CITY OF LINCOLN/LANCASTER COUNTY PLANNING STAFF REPORT

P.A.S.: Final Plat No. 02007
Stone Bridge Creek Addition

STONE BRIDGE CREEK ADDITION

Subject: Final Plat #02007, Stone Bridge Creek Addition

SHEET 8 OF 10

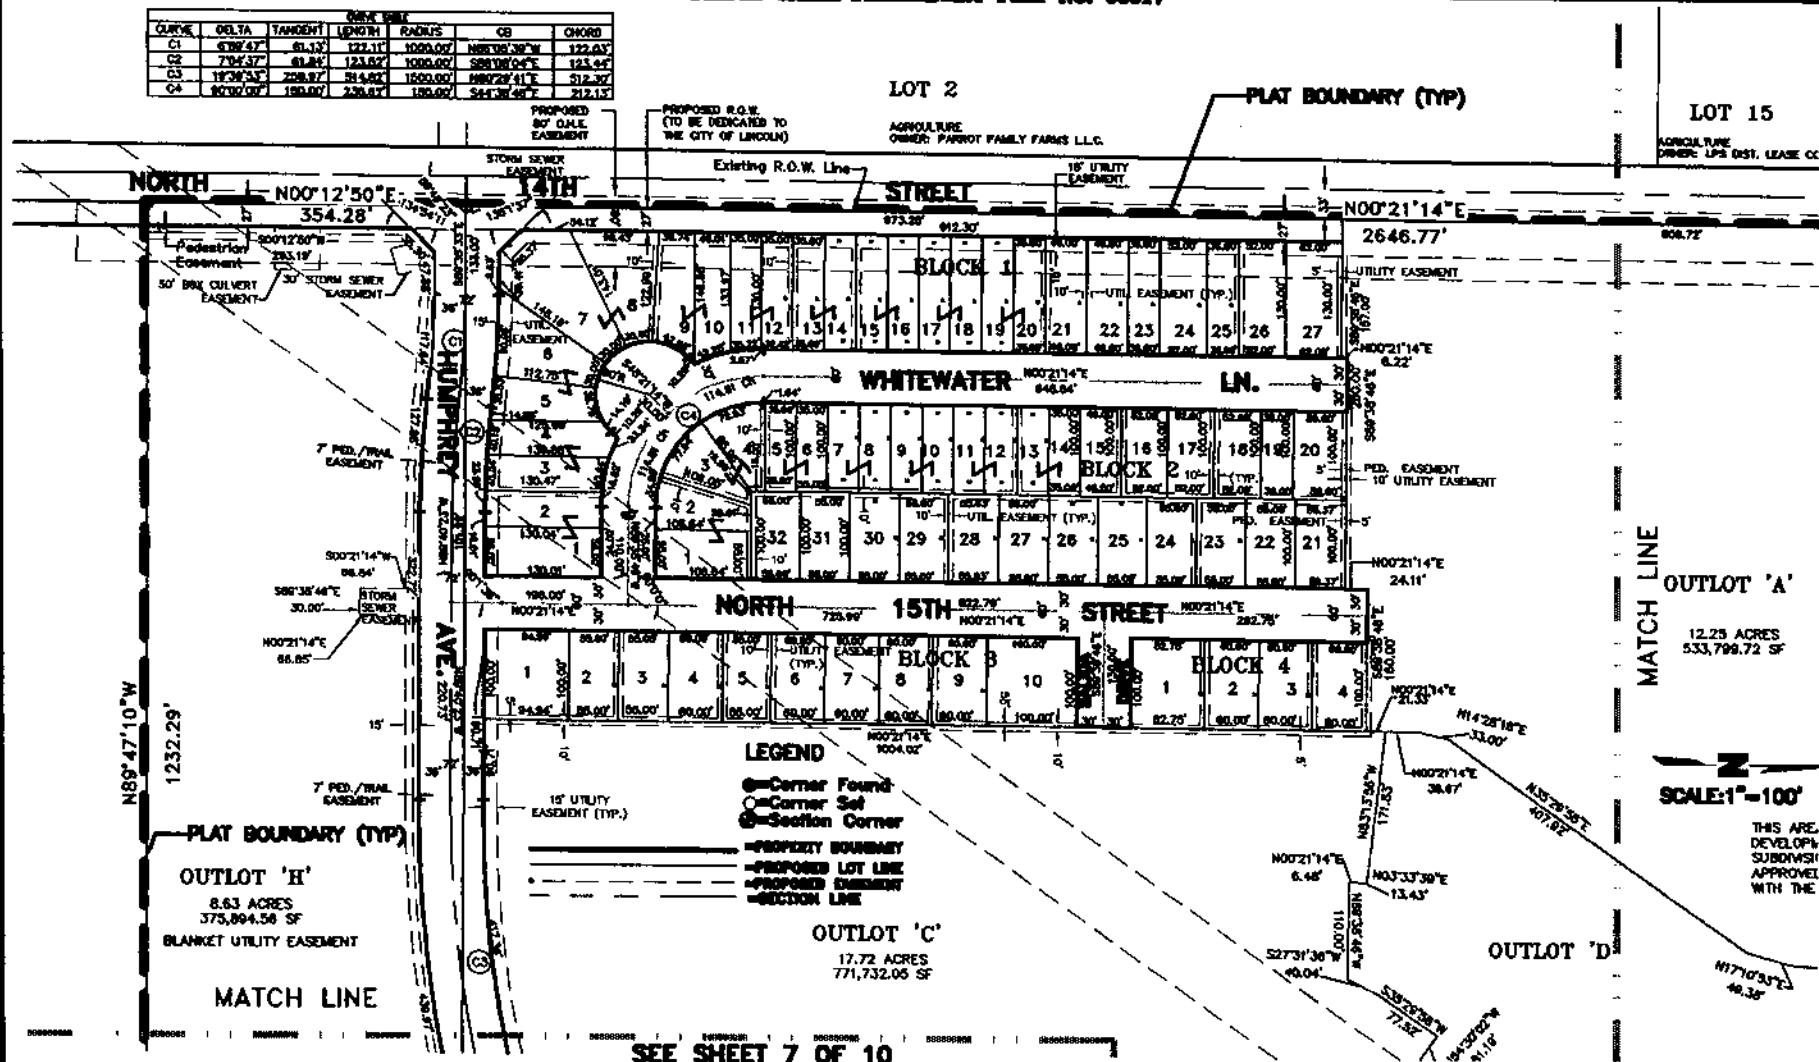
SJT - SHT. 8 - LINE RUNNING THROUGH BLK 1 & BLK 2, REMOVE IT

- BLK 1, LOT 9 DIM TOO LONG

- CURVE C1. BEARING SHOULD BE W, NOT E
